Thank you for your letter dated 24th October regarding White Young Greens submission regarding the Waste Licence Application for the Fingal Landfill at Nevitt, Lusk, Co. Dublin (Waste Licence Reference Number W0231-01).

FINGAL LANDFILL PROJECT REVIEW OF EIS – SOILS/GEOLOGY/HYDROGEOLOGY

Nevitt Lusk Action Group

October 2006

Fingal Landfill EIS Preliminary Well Survey		
Figure No. 1	Job No. CE05395	Date. Oct. 2006
	Finalised By - KLI

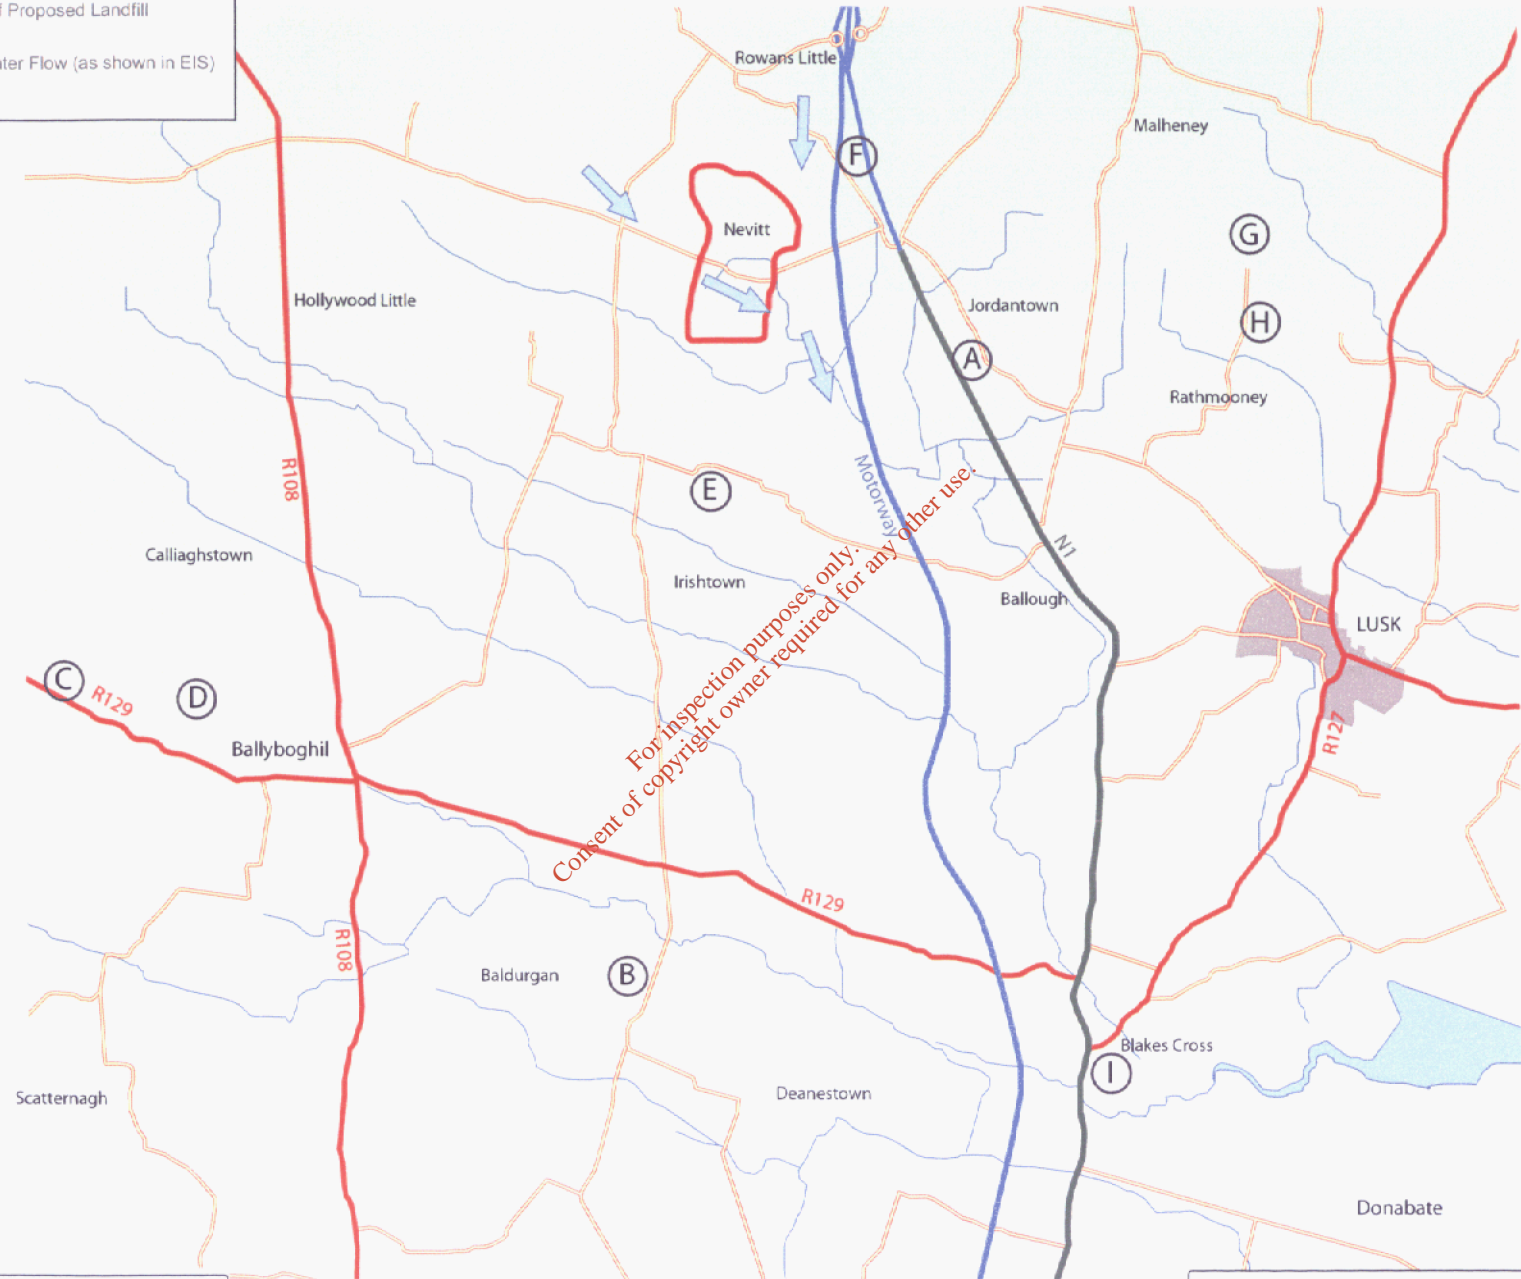
- Dunnes Well Drilling Services, a local well drilling company, provided records of the wells they have drilled in the area in recent years.
- WYG carried out a door to door well survey to identify any additional wells not accounted for by the Dunnes records (locations shown in Figure 1 attached)

The well survey conducted by WYG aimed to identify any wells in the area that had not been accounted for in the information provided by Dunnes. The well survey was carried out over 1 day so it is possible that other wells, not identified in the survey, exist also. This survey focussed on the large groundwater users in the catchment, namely the market gardens and horticulture industry. Ten wells were identified as follows:

Well I.D (Figure 1)	User Name	Abstraction Rate (m ³ /d)	Aquifer	Comment
A	Thomas Moore	654	Bedrock	Vegetable processing plant
B	Tim Bergin	2725	Bedrock	Irrigation and domestic use for up to 10 farmers
C	Paddy Keogh	1635	Gravel	Packing, washing
D	John Roggers	436	Bedrock	
E	Thomas Kerrigan	1962	Bedrock	Vegetable processing plant
F	John Thorn	872	Bedrock	Spraying
G	Country Crest	3216	Bedrock	Food processing
H	John Murray	872	Bedrock	Cucumber grower
I	John Landy	436	Gravels	Tomato and lettuce grower

2D-Resistivity Profile 1A (EIS_2005)

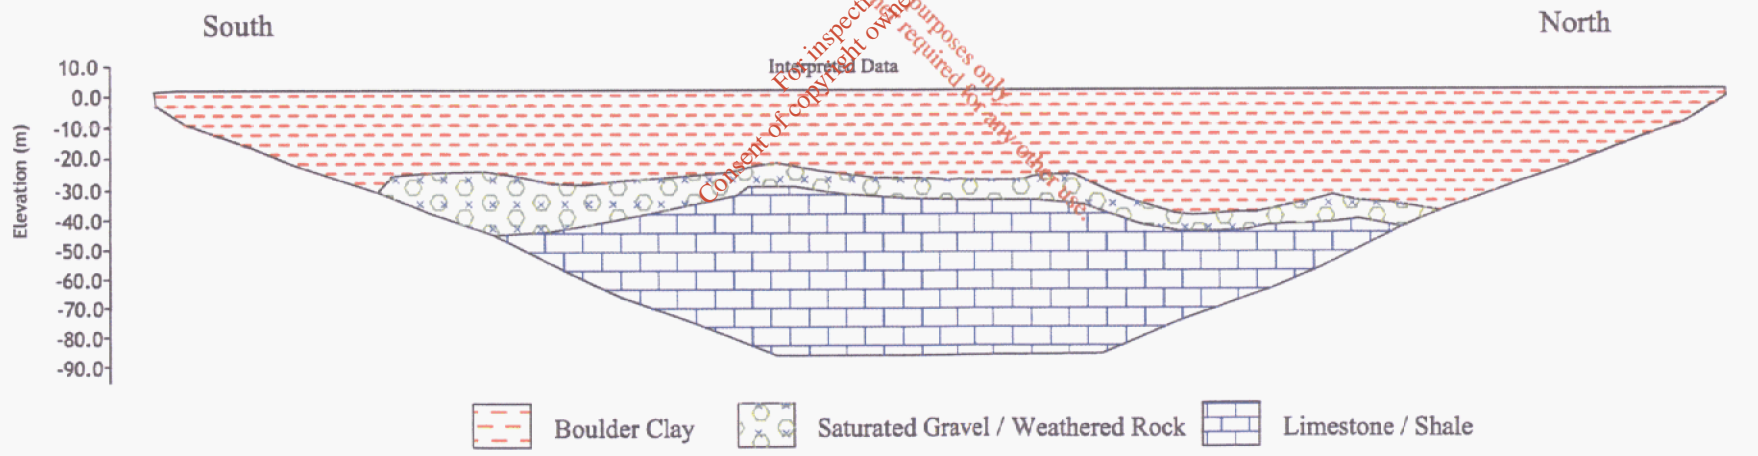
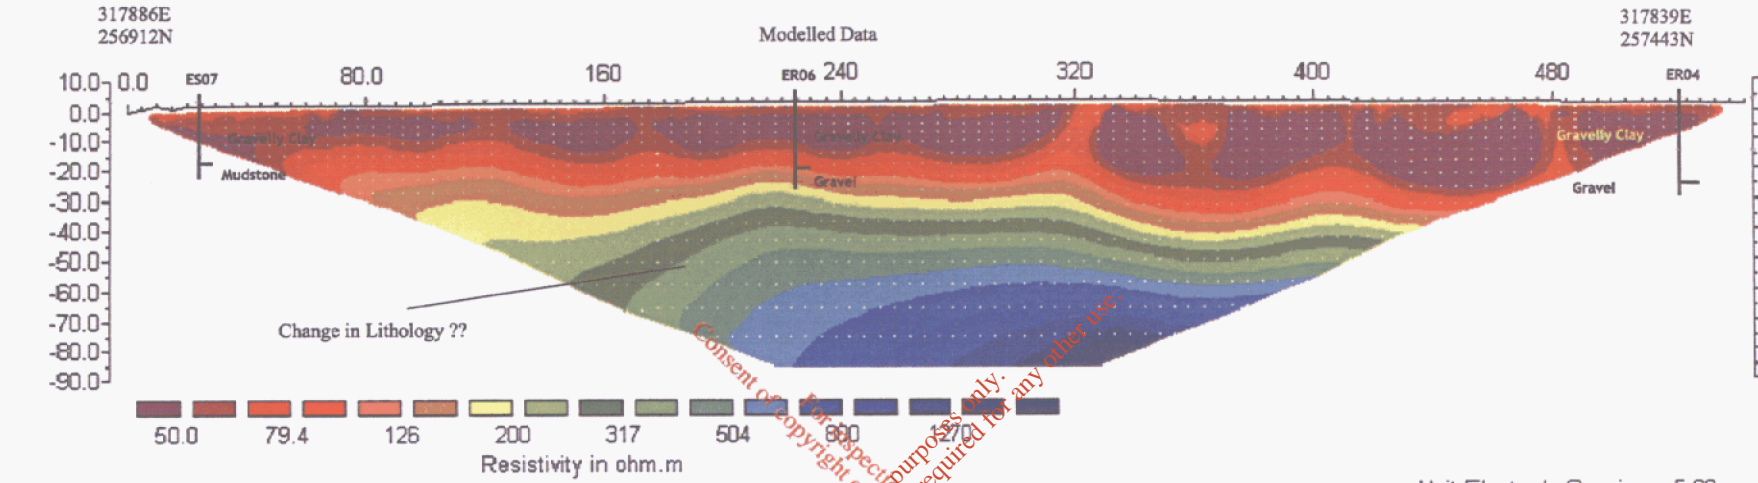
An examination of the resistivity profiles included in the geophysical report indicates that a large number of these profiles right across the site recorded the presence of gravel at depths ranging from 2-5m to 20-35m. This detail is presented in the table below:

While some appear to be isolated gravels, the geophysical profiles show areas in the centre of the site that appear to be underlain by continuous gravel deposits. The EIS acknowledges the presence of 'some sand and gravel deposits' that 'vary across the study area with thicknesses ranging from absent

to 10m'. However, the EIS fails to adequately discuss or further investigate the gravels identified directly beneath the landfill footprint by the geophysical survey. The drilling work carried out subsequent to the geophysics should have specifically targeted the areas identified as being underlain by gravel. If this was carried out, it would be possible to produce a detailed contour map of the subsurface particularly showing the areas where gravel is present less than 10m below the surface.
